AAIB SAFETY RECOMMENDATION EMBRAER 145 DFDR PERFORMANCE

Recommendation 2002-01

figure 1

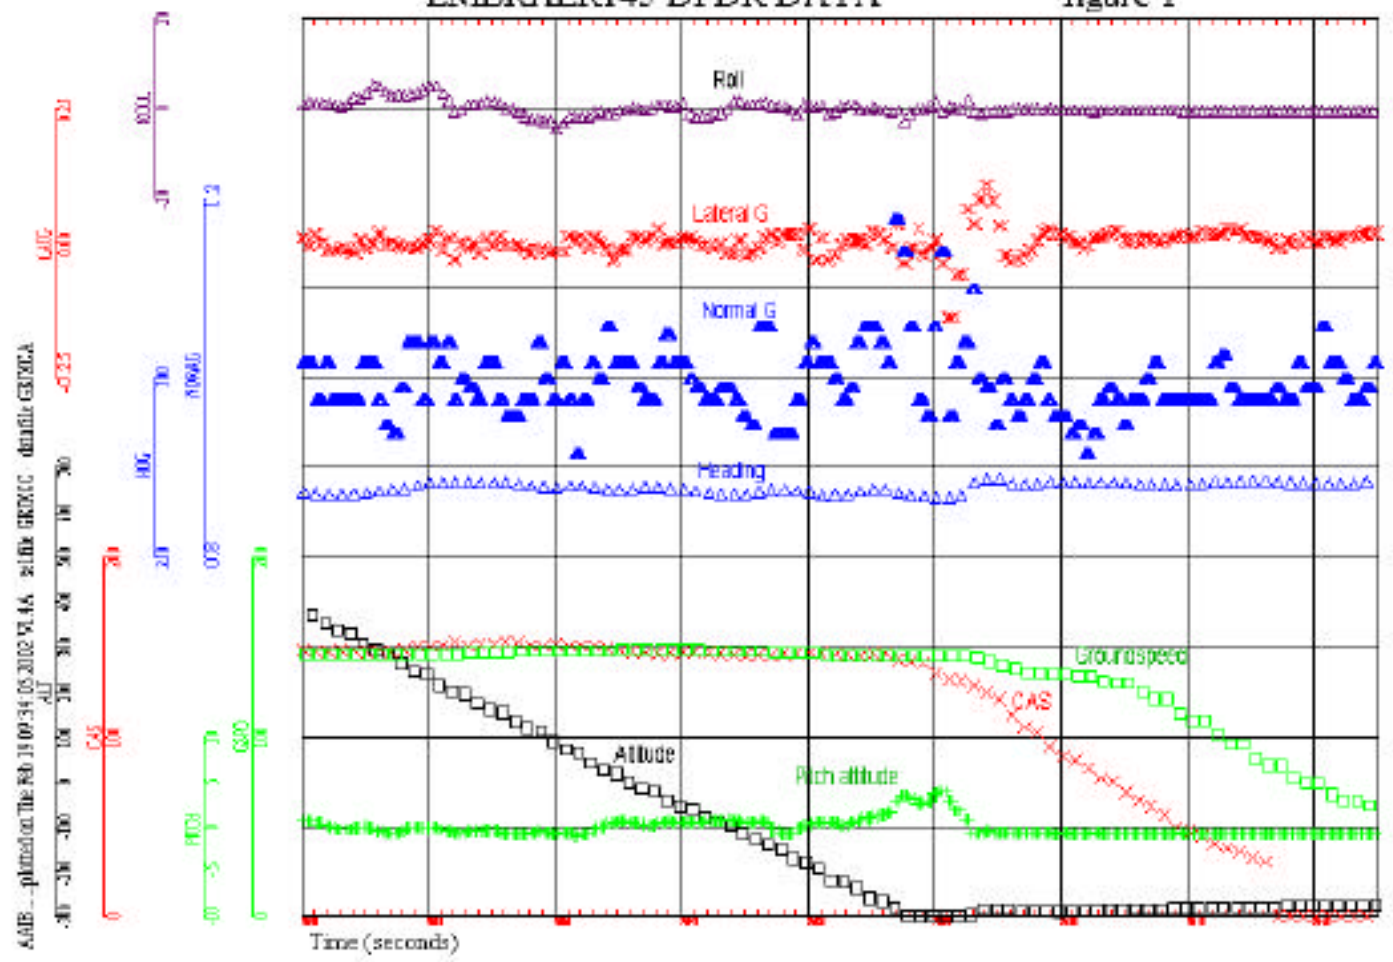
Figure 1 shows a time history of selected parameters recovered from the DFDR fitted to G-RJXC recorded during the incident landing. Pitch Attitude and Lateral Acceleration are sampled at 0.25 second intervals, Normal Acceleration at 0.125 second interval, Roll Attitude at 0.5 second interval and Altitude, CAS, Groundspeed and Heading at 1 second intervals.

figure 2

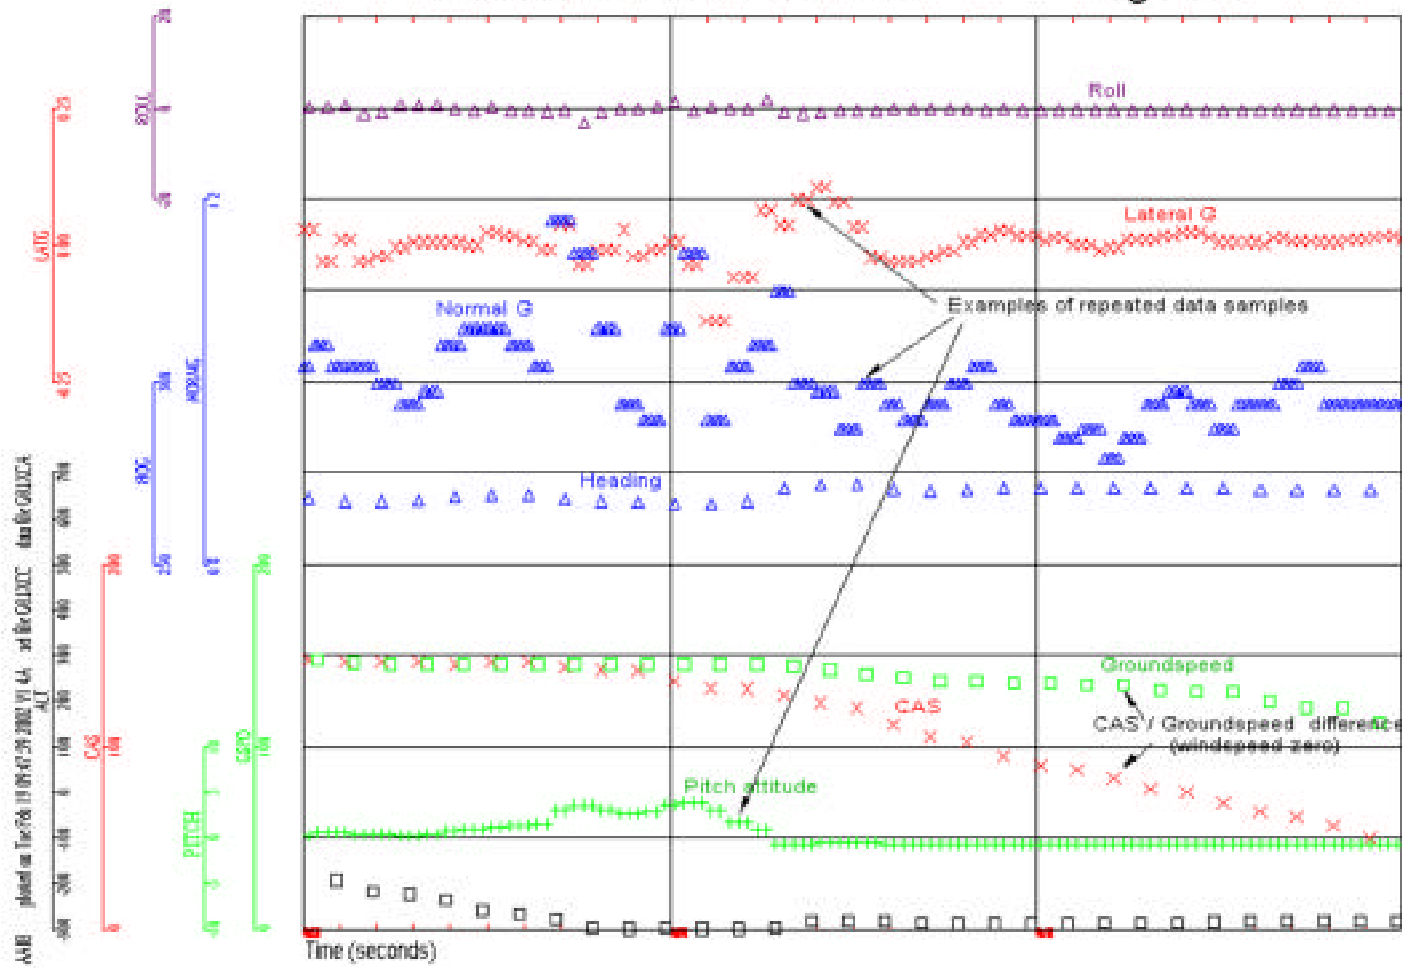
Figure 2 shows the data recorded during the “flare” in an expanded form and figure 3 shows similar data in the form of a numerical listing. The stepped nature of the time histories and the number of times a data sample is repeated are inconsistent with the dynamic conditions that existed immediately before the aircraft landed. Of concern is the repetition of the same data value. In one of the other incidents a Normal Acceleration value remained constant for 34 samples (in excess of 4 seconds) whilst the aircraft was flaring. This repetition of values is an indication that the

resolution in recording is variable and inadequately low. It is possible that the samples are not being updated as they should be and this is causing the effective inadequate resolution.

Whilst it is certain that there are errors in the recording of the above parameters. It is also possible that anomalies exist in parameters recorded at 1 sample or less per second. In particular Groundspeed appears on many occasions to be incompatible with recorded airspeed. Figure 2 shows possible repeated data values and a marked difference in the values of CAS and Groundspeed in conditions where there was no headwind component. On occasion the recorded engine N1 speed and Altitude also appear to be incompatible with the designed resolution and sampling rate.

As a matter of urgency, the Centro Tecnico Aeroespacial (CTA) of Brazil should require Embraer and the manufacturers of the flight data recording installation to investigate the nature and extent of the recording anomalies associated with the EMB145 DFDR installation, to correct them on existing and future aircraft, and subsequently demonstrate that the DFDR faithfully records the time histories of the data transducer outputs. The CAA as part of its JAA activities should monitor this process.
